Date  
18-12-2025

J nr. 2024 - 1977

## Decision regarding approving the storage plan for Nini A (Nini West) for permit C2023/01

Fig. 3. (Figur 13-9 i miljökonsekvensrapporten). Havsoverfladens pH värderier. Statistiske minimumsværdier for simuleringsperioden på 14 dage.

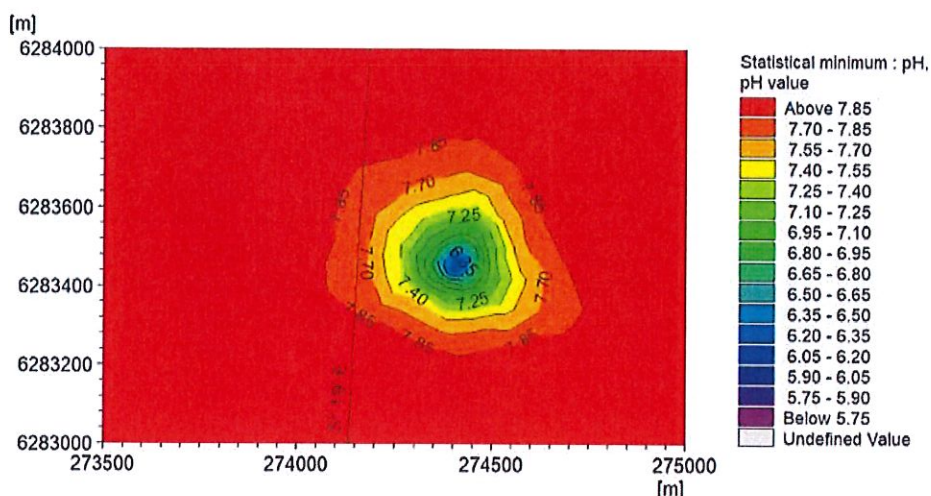
När det gäller figurerna över modellerat pH i kapitel 13 i miljökonsekvensrapporten, rekommenderar myndigheten precis som tidigare att använda en skala och upplösning som inkluderar den typiska pH variationen i Nordsjön även om modellerade data ligger under denna (se Fig. 3). I tillägg vore det lämpligt att också visa figurer på avvikelser i pH från de initiala förhållandena, då det därmed framgår om vattnet har en signal av försurning från CO<sub>2</sub> utsläppen. När det gäller tabell 13-9 och 13-10 vore det också lämpligt att inkludera fler pH nivåer då många marina organismer är känsliga för pH värden långt över 7.5.

Vidare önskar SMHI att förtydliga att alla figurer med det statistiska minimum pH visar på en genomgående havsförurning då pH är i intervallet  $7.5 < \text{pH} < 8$  eller lägre (se till exempel Fig. 3 ovan, men även Fig. 13-10 i miljökonsekvensrapporten). Dessa värden är jämförbara med IPCC:s projicerade ytvatten pH scenarier SSP2-4.5, SSP3-7.0 och SSP5-8.5 för slutet av detta århundrade (Fig. 4, IPCC, 2021).
